U. S. NUCLEAR REGULATORY COMMISSIONDOCKET NO. 50-295COMMONWEALTH EDISON COMPANYZION NUCLEAR POWER STATION, UNIT 1ISSUANCE OF DIRECTOR'S DECISION UNDER 10 CFR 2.206REGARDING INTEGRATED CONTAINMENT LEAK RATE TESTINGAT COMMERCIAL NUCLEAR POWER FACILITIES

SUBJECT: APPEAL OF MARCH 8, 1985 REGARDING VOLUMETRIX LEAK RATE COMPUTER PROGRAM

COMMONWEALTH EDISON COMPANY
(Zion Nuclear Power Station,
Unit 1)
AND ALL LIGHT-WATER REACTORS

DIRECTOR'S DECISION UNDER 10 CFR § 2.206

Fig. 2.7 - Plan View of Sensor Locations, Subvolume 7

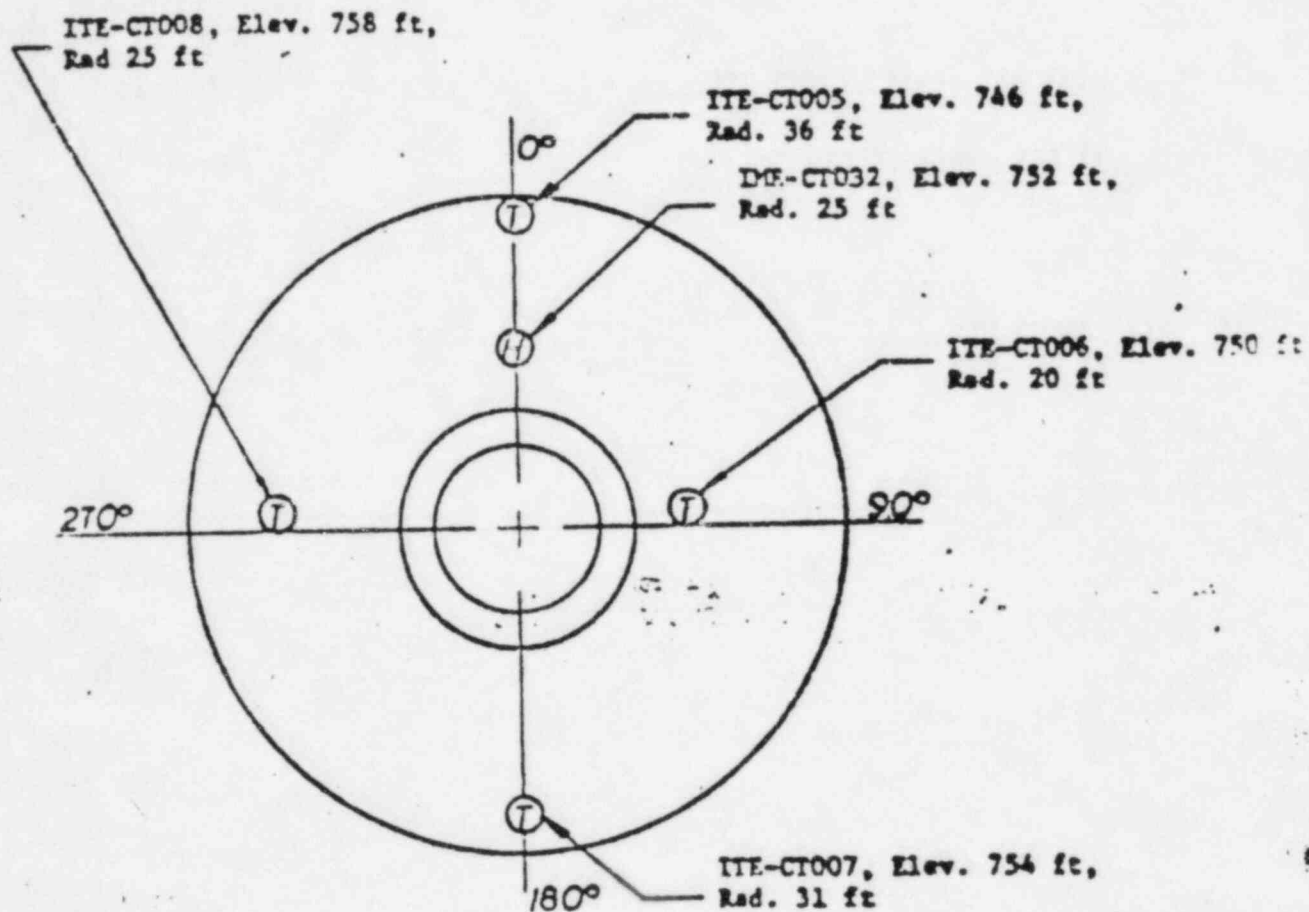
As stated above, the Volumetrics software was not used in the Zion tests. Nevertheless, the Petitioner presented a data set of nine temperature readings for a particular subvolume ~~(stated to be from a Zion test)~~ to show that the Volumetrics computer program does not correctly calculate the average containment temperature. The Petitioner, however, mistakenly included the readings of two channels (numbers 4 and 14) that had been declared "out-of-service" throughout the course of the test. Therefore, the computer program in use (not the Volumetrics program) was averaging, correctly, the readings of the seven "in-service" channels. The staff also is not aware of any "fraudulent" doubling option in the Volumetrics computer program, as the Petitioner alleges. In any event, such an option could not have been used in the cited Zion test since the Volumetrics computer program was not used.

FIG. 1

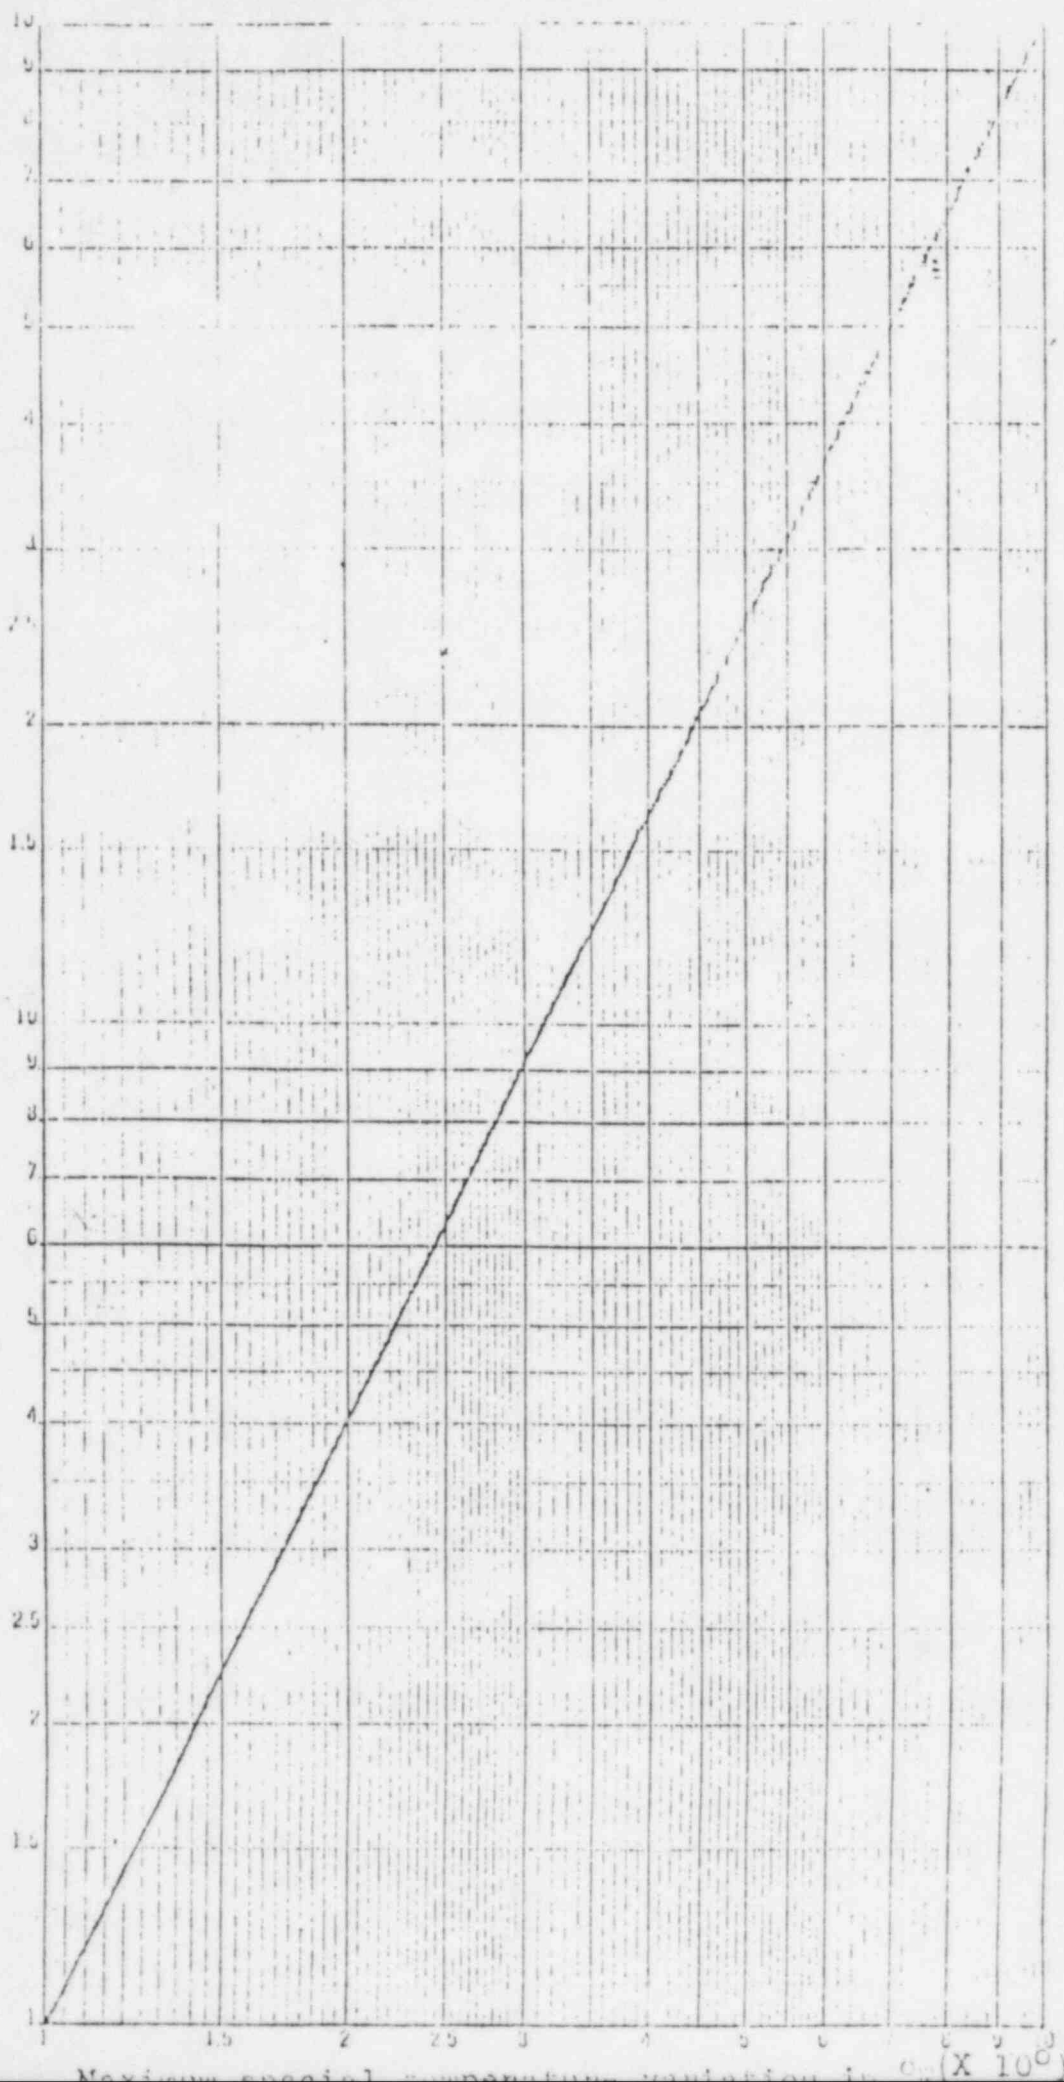
Although simulation has no bearing on regulatory documents where only worked negative examples and conservative estimates (bounds) may provide basis for rulemaking, actual error magnitude can be grasped using simulation. Some results in this direction have been obtained by the ORNL. However, results published in the ORNL/TR-8909 fall out of the practically important range from 10° to 70°F. As is shown below, a totally wrong decision about "adequacy" of the wrong ANSI/ANS mass equation was based on such incomplete data. To fill this gap, an analytic investigation was done using various realistic assumptions on spacial temperature distribution. A typical relationship between the maximum spacial temperature distribution and the most likely error resulting from usage of the wrong ANSI/ANS equation is shown in Fig. 1. Actual errors can be several times larger or several times less than the most likely error (which is the so-called mathematical expectation).
